FAQ Number 10-0059 **FAQ Revision** 2

FAQ Title NFPA 805 Monitoring

Plant:	<u>Harris Nuclear Plant</u>	Date:	<u>August 19, 2011</u>
Contact:	<u>Joelle DeJoseph/ Dave Miskiewicz</u>	Phone:	<u>919-546-6247</u>
		Email:	<u>joelle.dejoseph@pgnmail.com</u>

Figure E-1 – NFPA 805 Monitoring Process

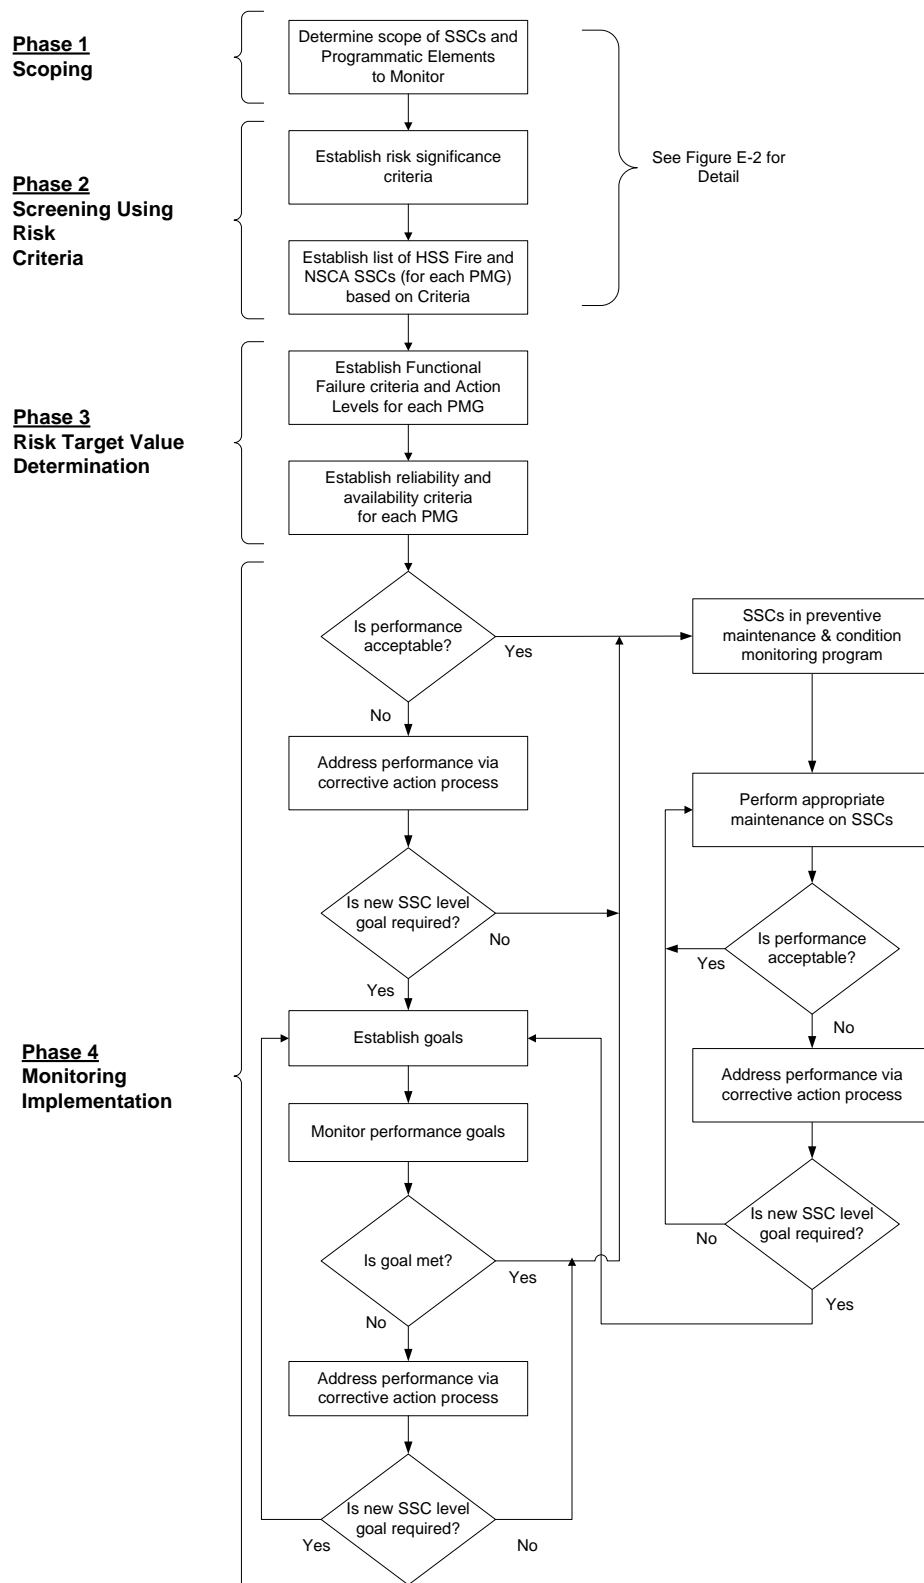
REPLACE ALL OF APPENDIX E WITH THE FOLLOWING:

A suggested methodology is outlined below. Figure E-1 provides an overview of the Monitoring Process, while Figure E-2 provides detail on a process for Phases 1 and 2.
